PENDLETON AVENUE
FALL CREEK R.W.D. PLAN & PROFILE SHEET
HORIZ. 1"=50'
VERT. 1"=10'
BEAM, LONGEST & NEFF, INC.
CONSULTING ENGINEERS
INDIANAPOLIS, INDIANA

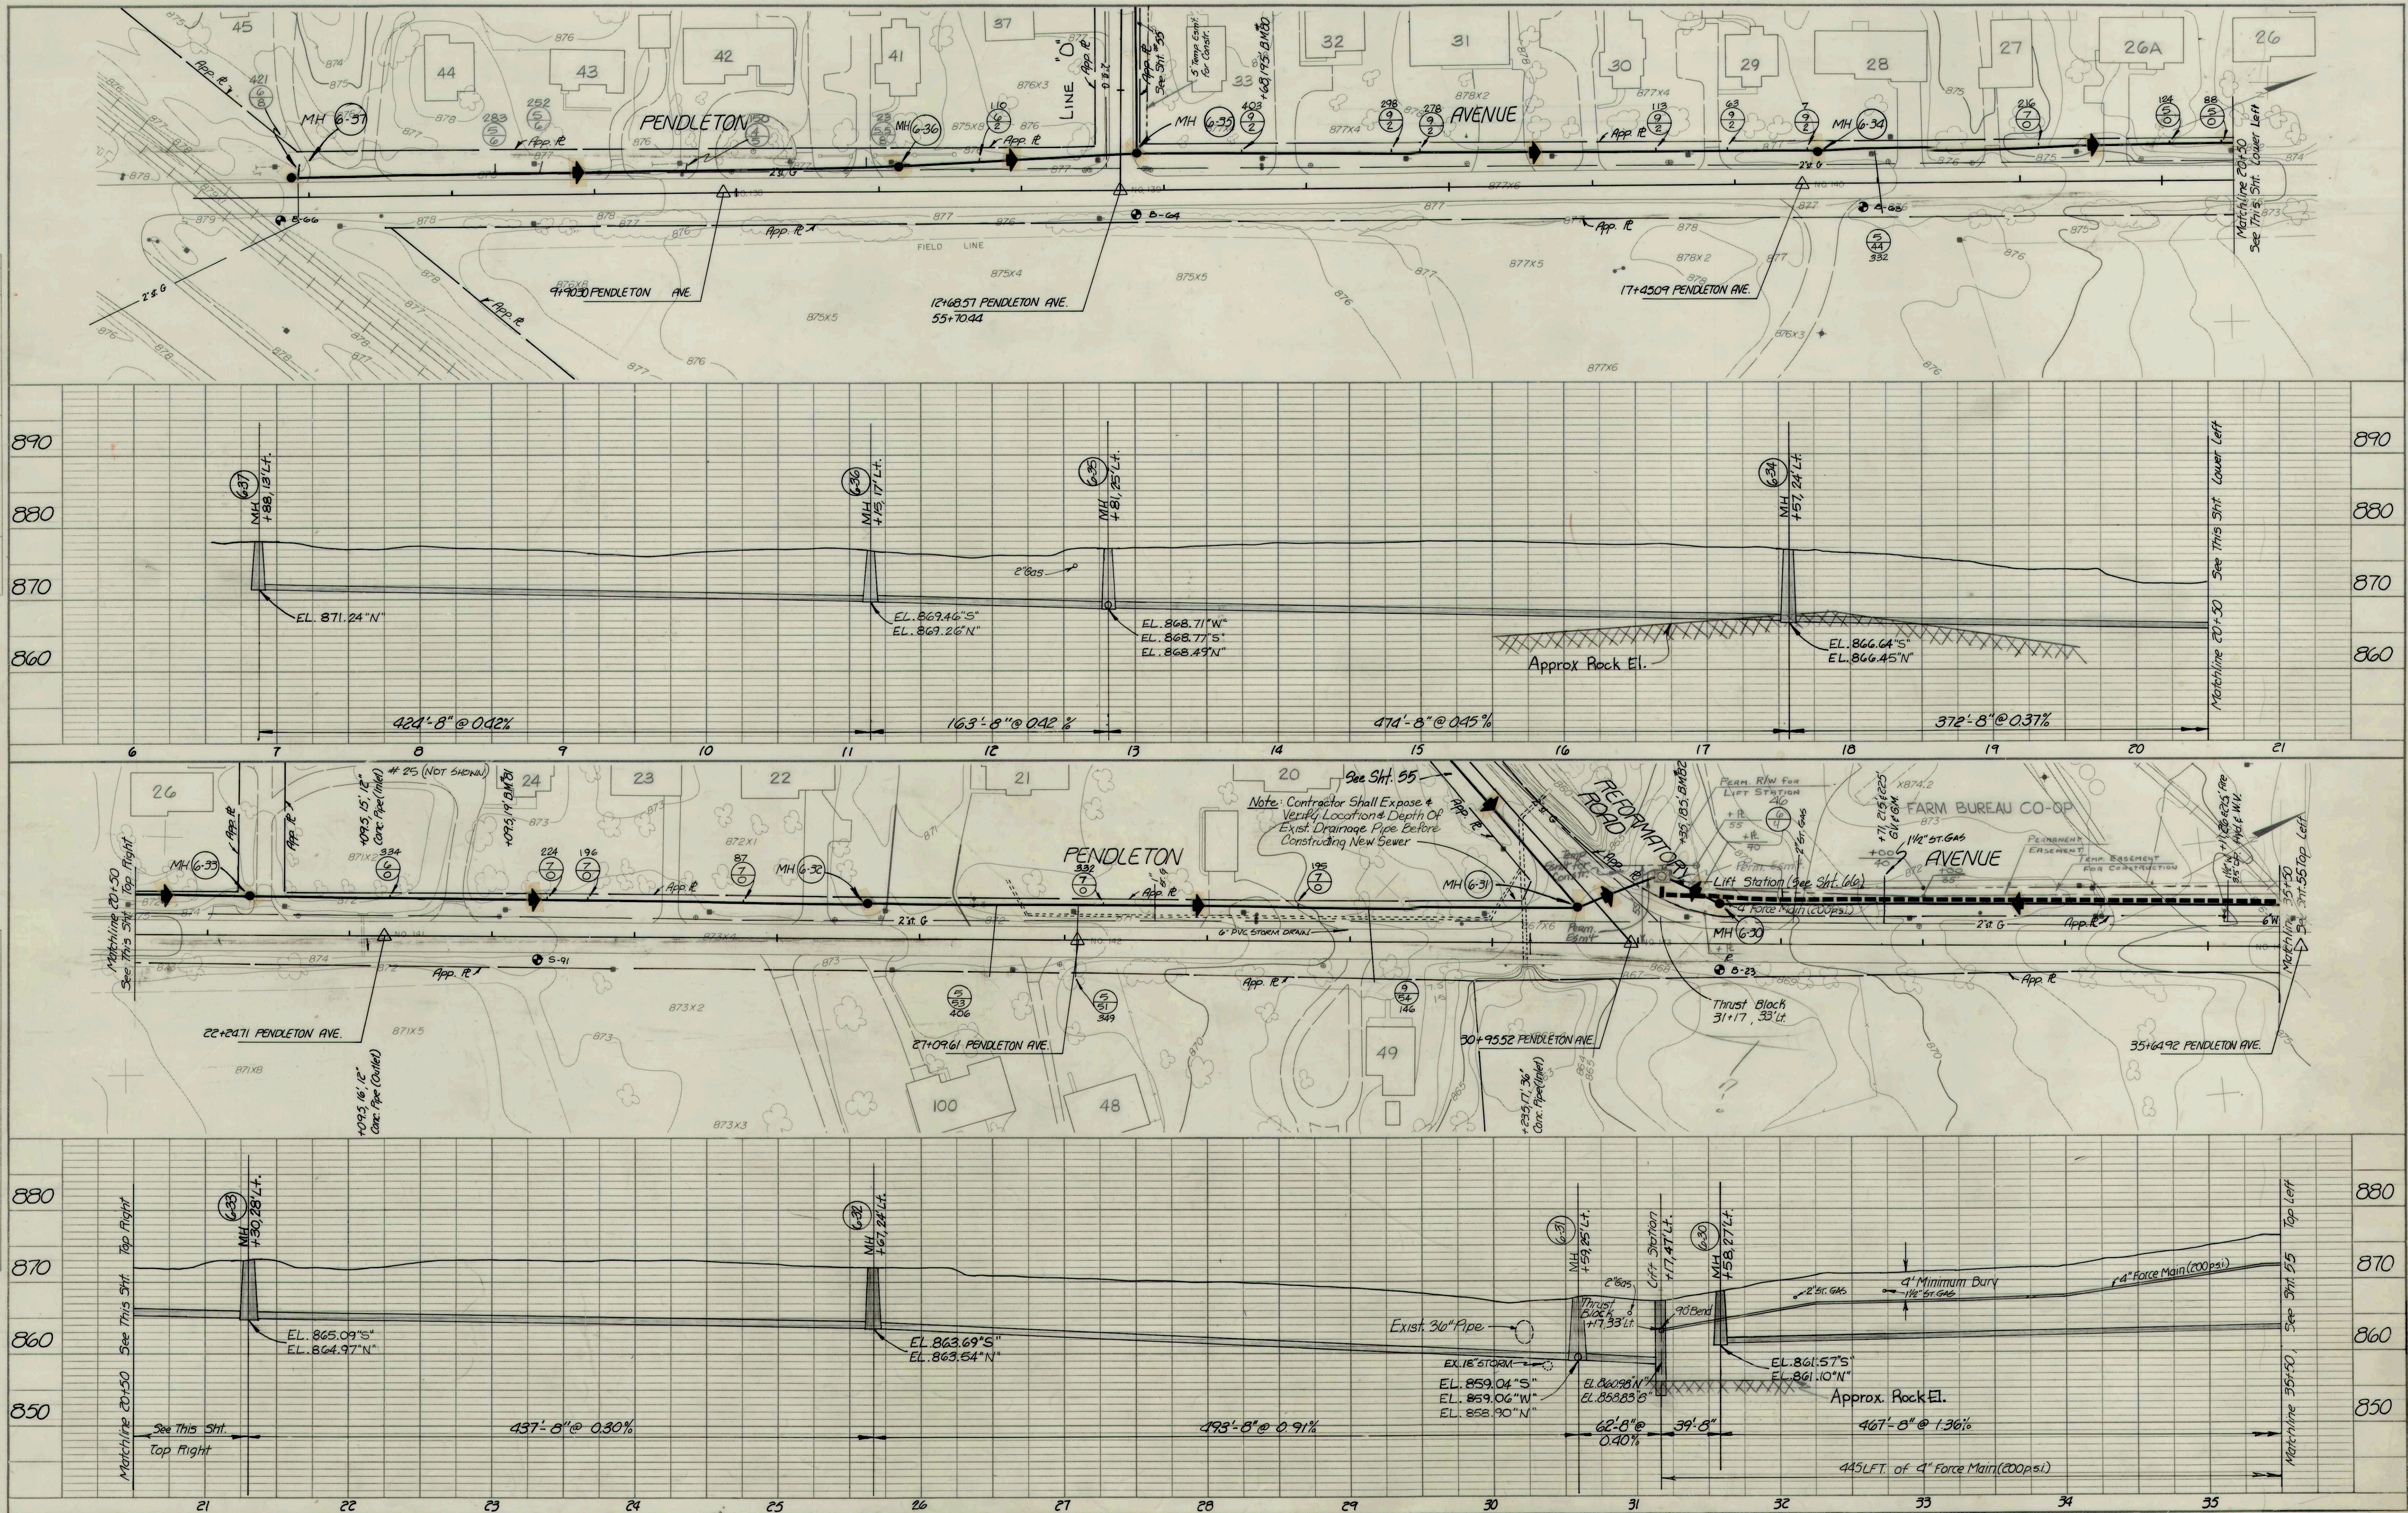
- ① NEED ELEVATIONS OF IN/OUT LINES @ LIFT STATION.
 - ② NEED LOCATION OF 4" PVC FM @ LIFT STATION.
 - ③ NEED LOCATION OF CATCH BASIN @ RAINBOWS.
 - ④ NEED ABOUT LENGTHS.
 - ⑤ NEED LOCATION OF TIGHT BENDS.
- BWC
3/14/85

REVISED 3-19-84
CHANGED R/W AROUND
RECORD DRAWING
Changed Grade From MH 6-30
To MH 6-28
